Addendum No. 6

PROJECT NO. 161026-00

PROJECT TITLE: Renovate Plant Science Building - Phase 2

DATE: **November 19, 2026**

D 2 GROUND FLOOR
F1.0 SCALE: 1/8" = 1'-0"

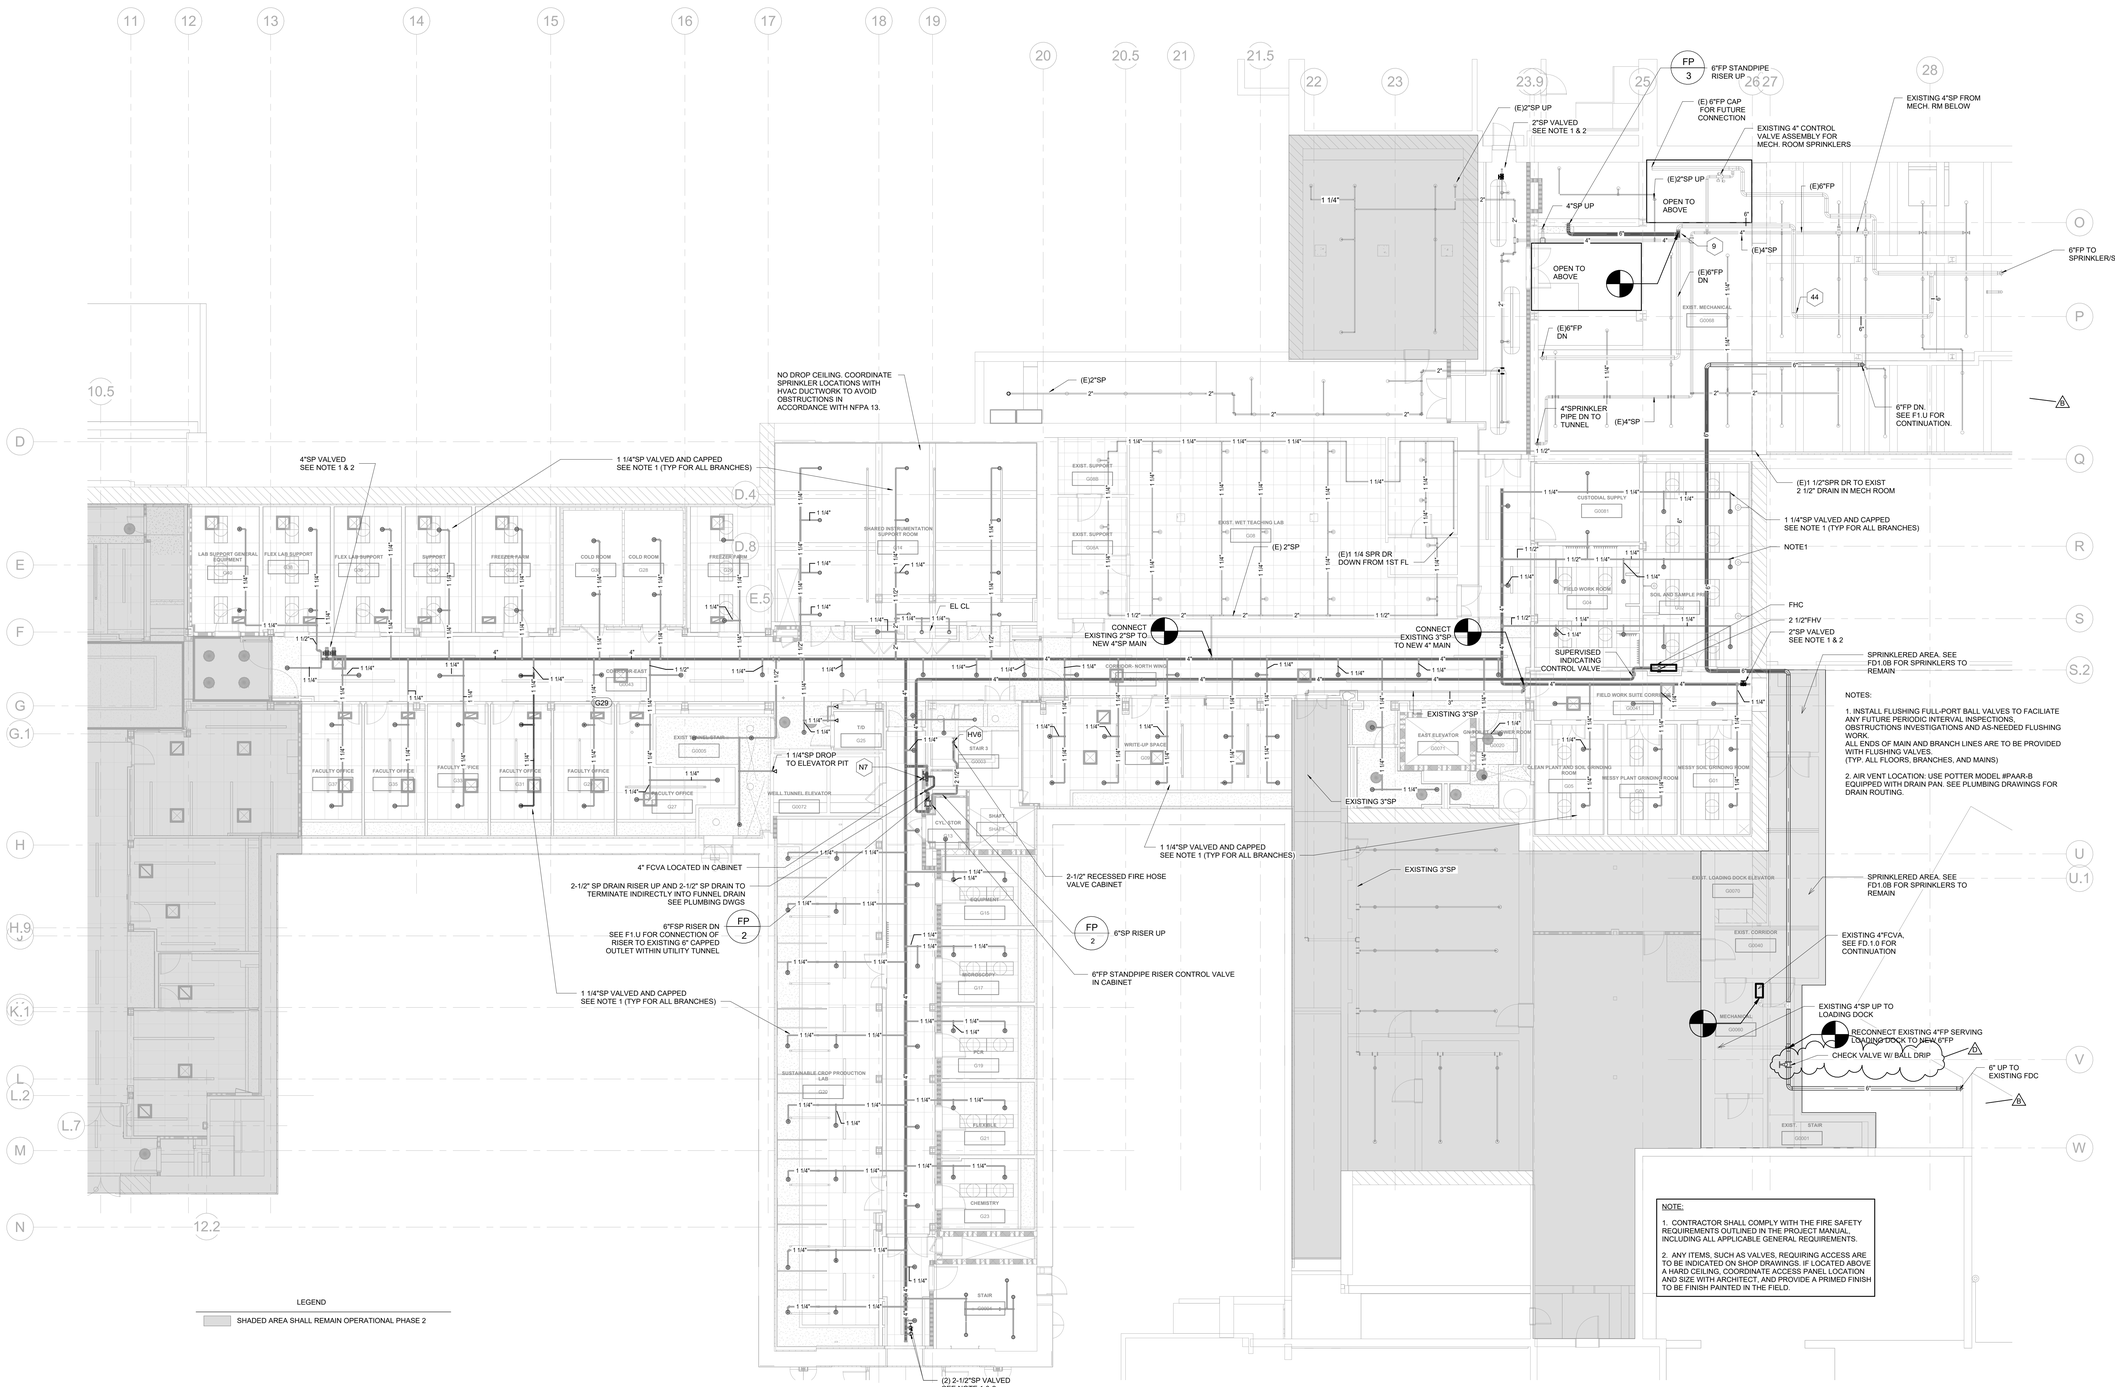
6.2aw: F1.0 – ADDED check valve with ball drip.

D | 1 — F2.1 SPRINKLER AND STADPIPE RISER DRIAGRAMS
SCALE: 12" = 1'-0"

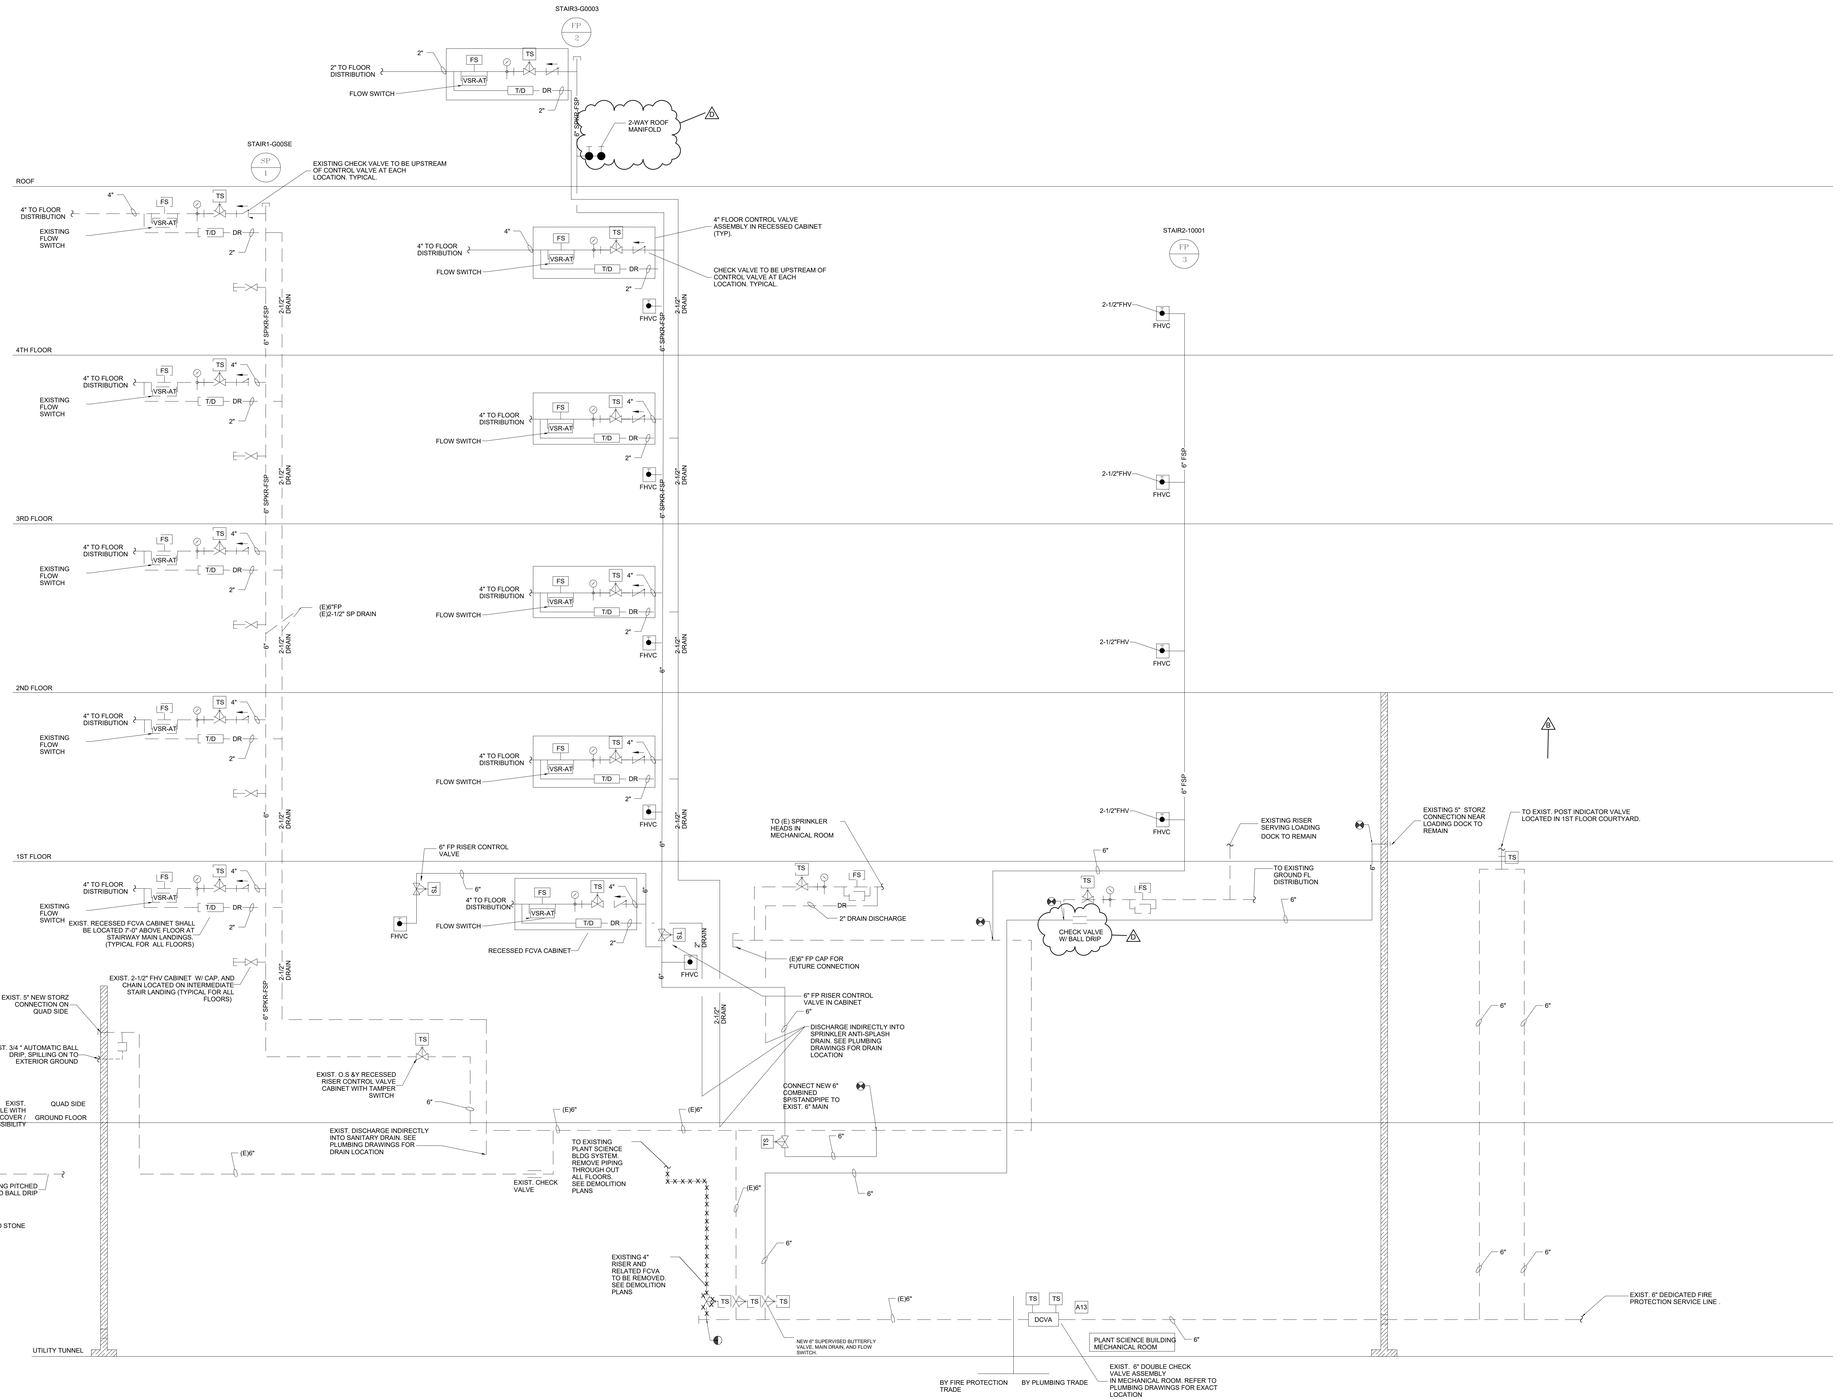
6.2ay: F2.1 – REVISED roof manifold, ADDED check valve with ball drip.

1 MECHANICAL GROUND FLOOR PIPING PLAN - PHASE 2
1/8" = 1'-0"

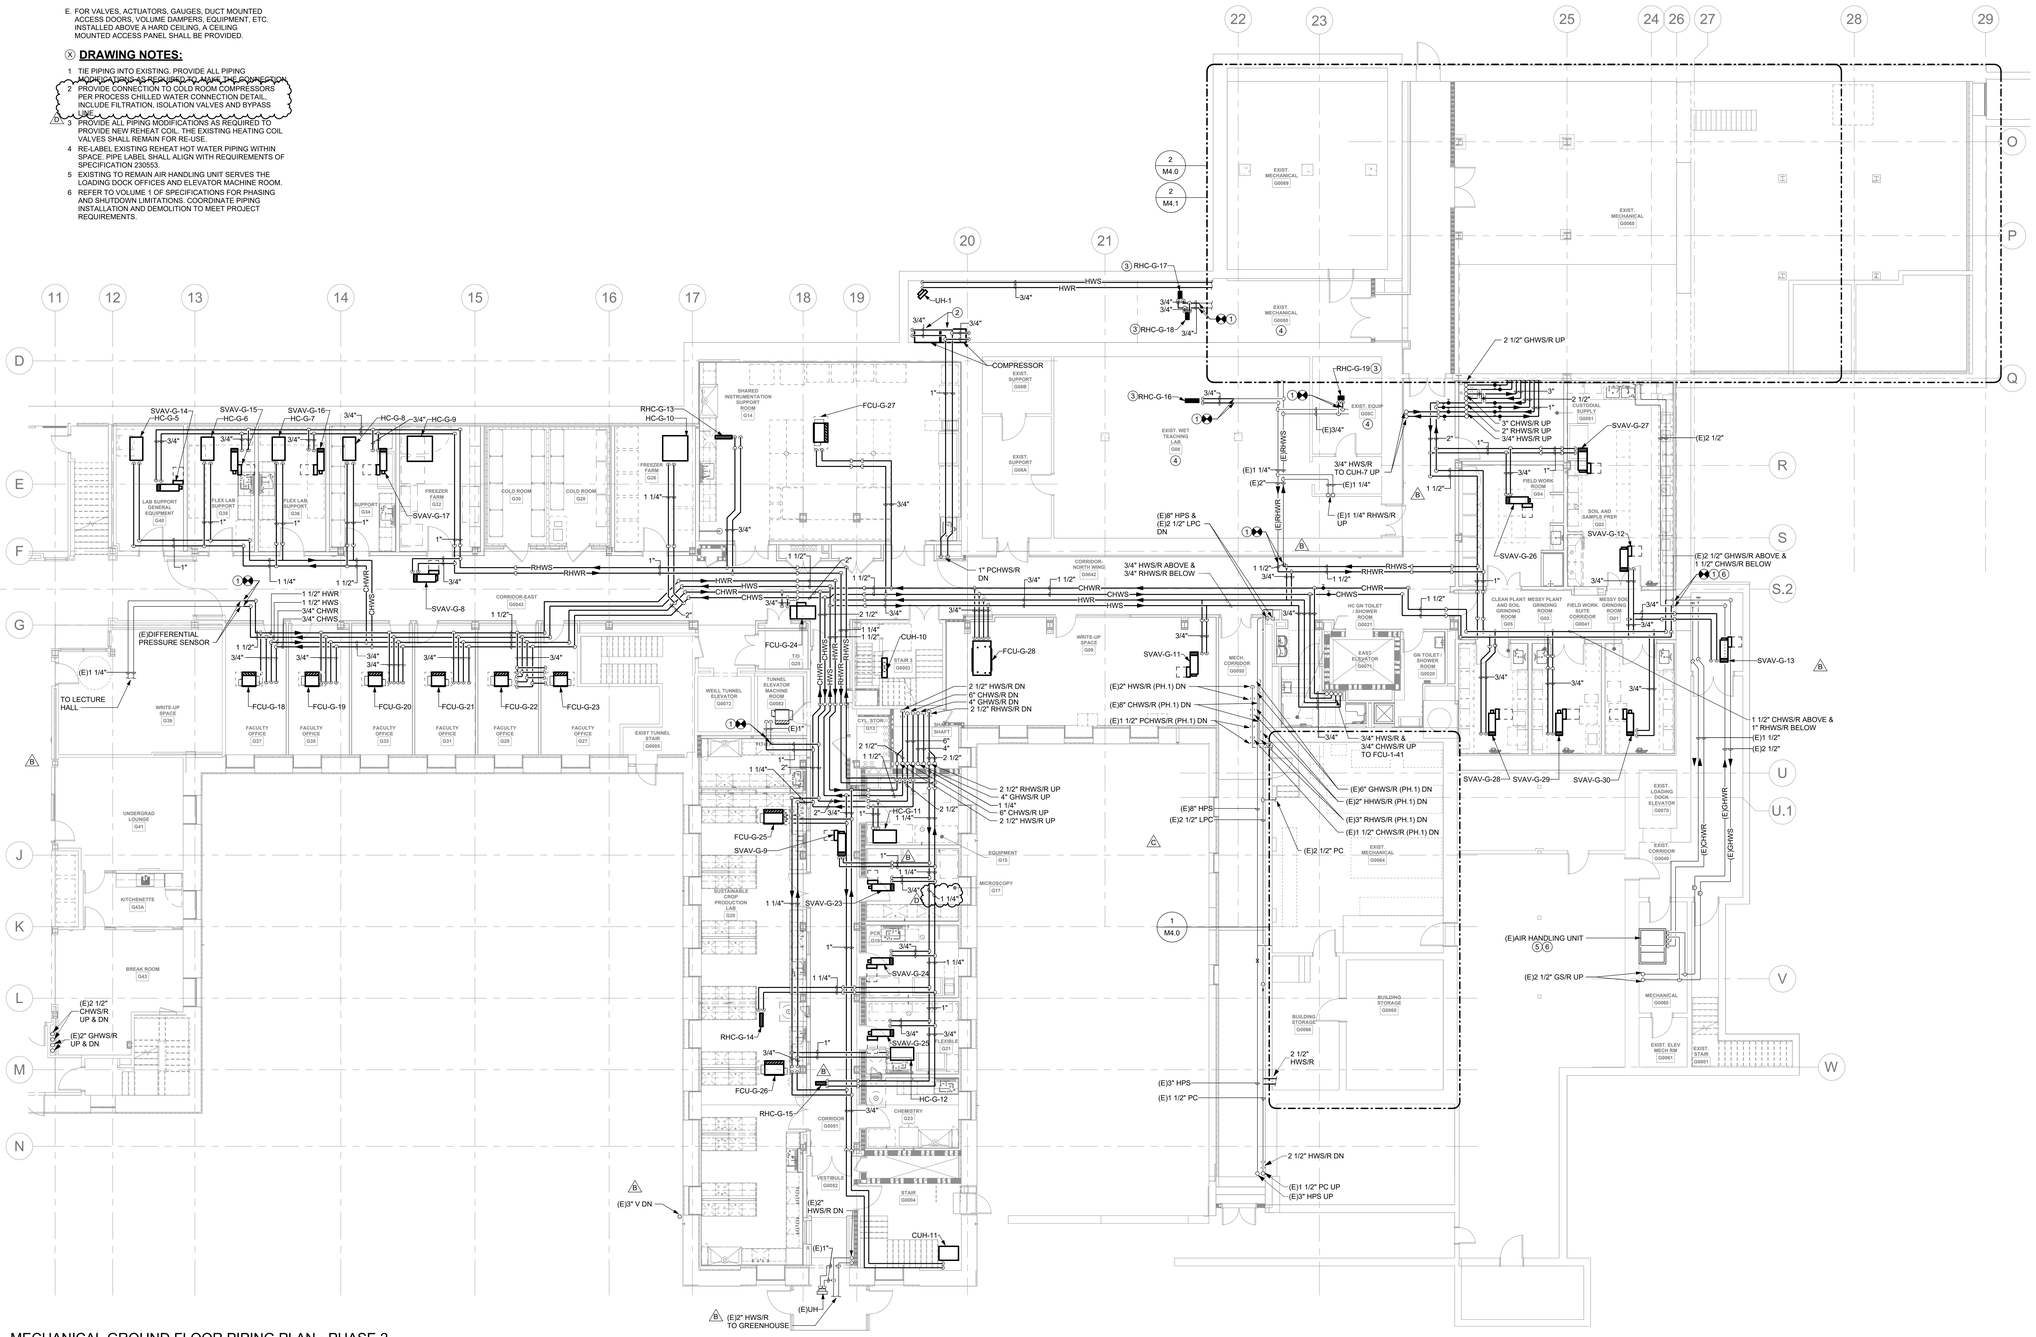
6.2bb: M2.0 – REVISED Drawing Note 2. REVISED 1 1/2" RHWS/R to 1 1/4" to RHWS/R.

1 MECHANICAL FIRST FLOOR PIPING PLAN - PHASE 2
1/8" = 1'-0"

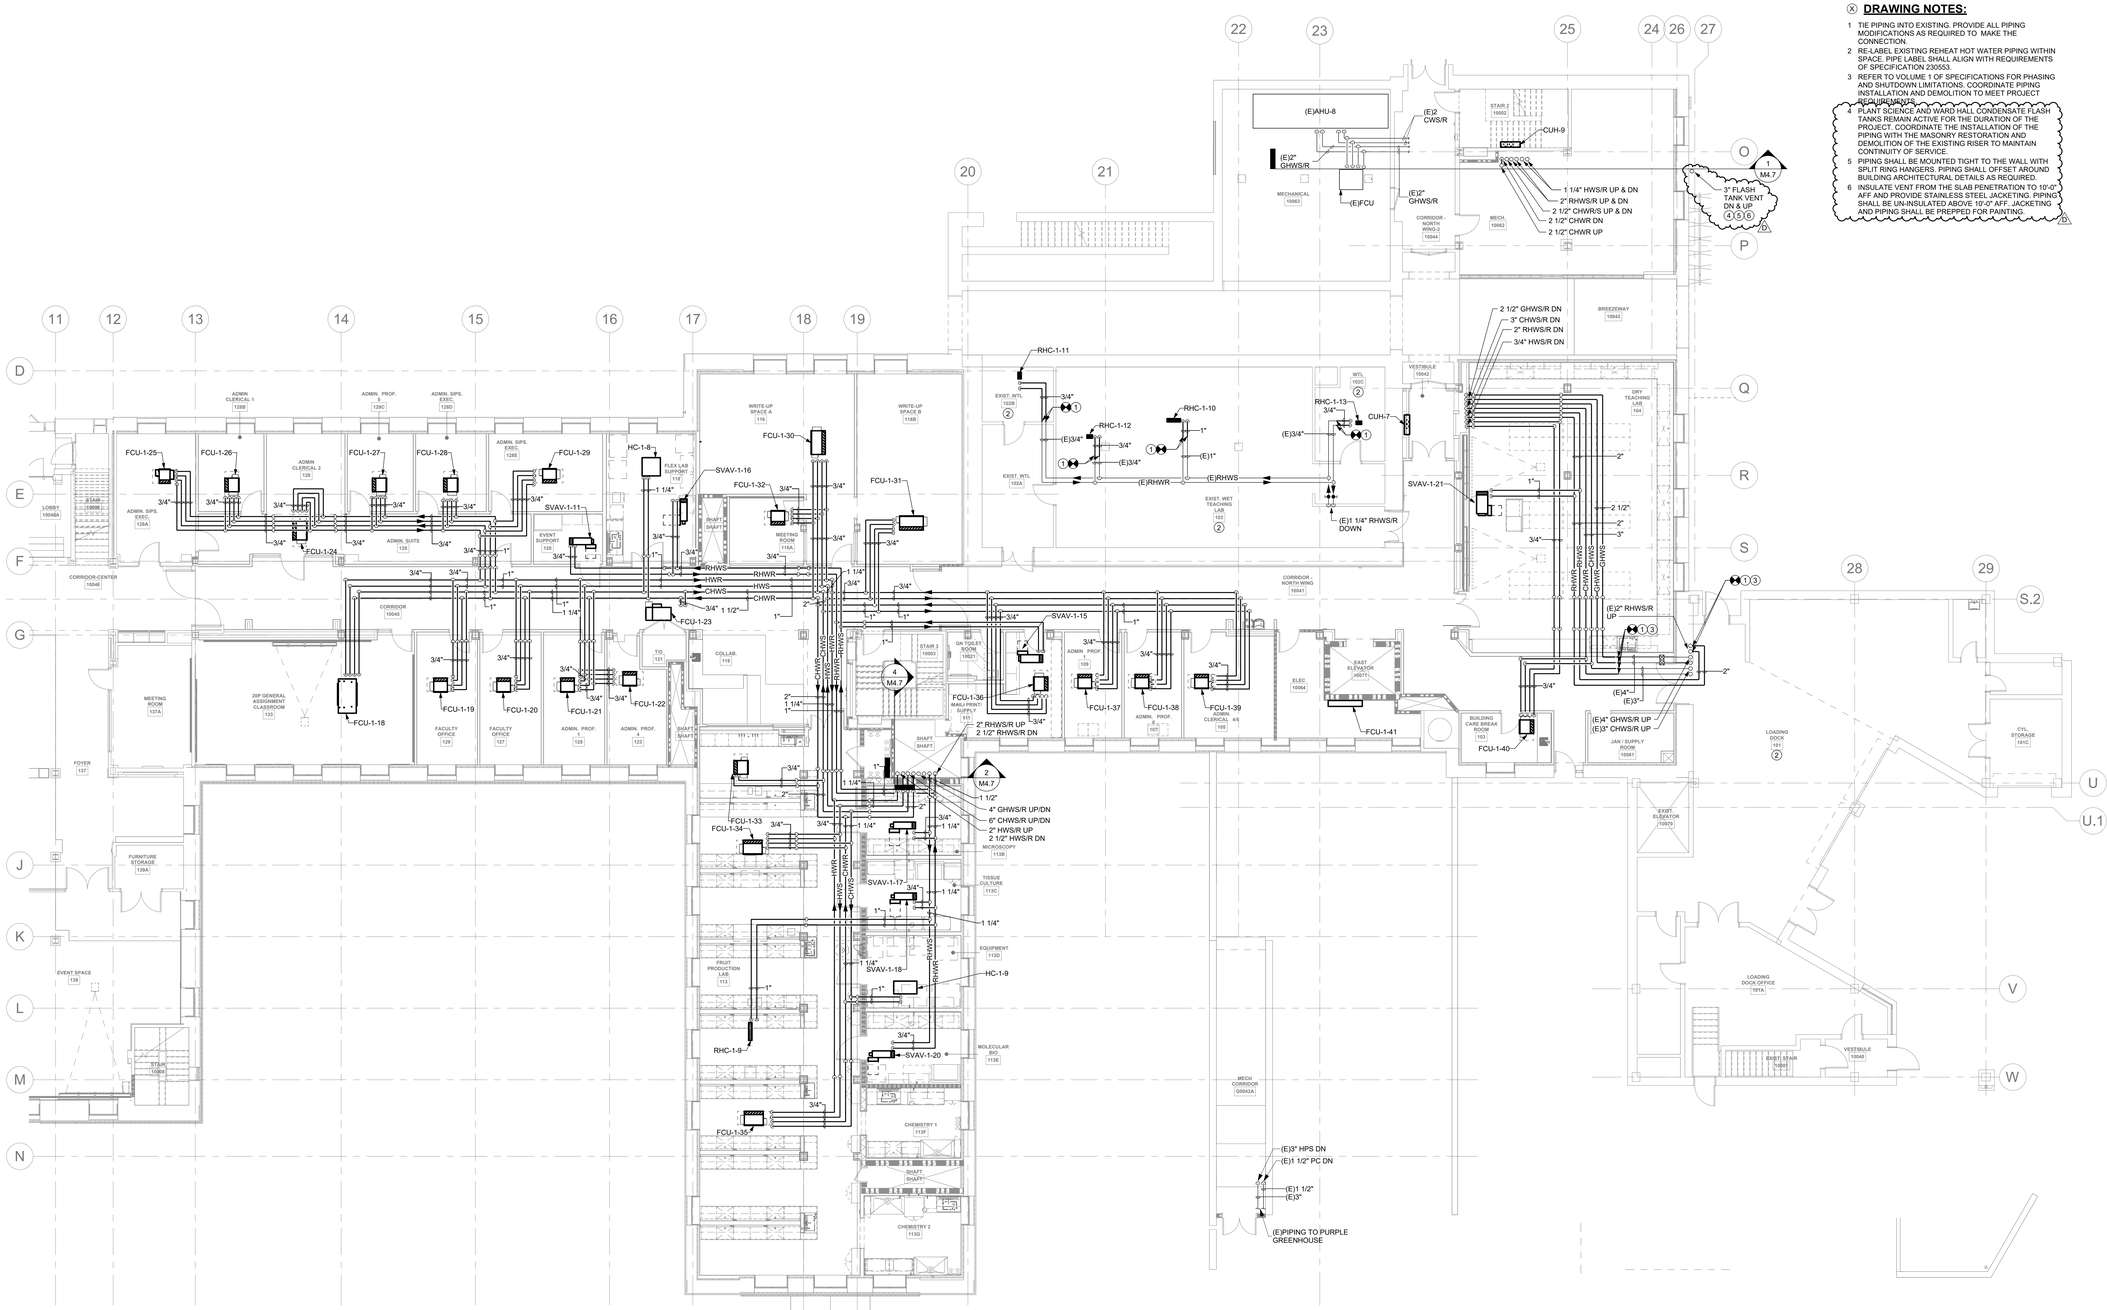
6.2bc: M2.1 – ADDED 3" Flash Tank Venting. ADDED Drawing Note 4, 5 and 6.
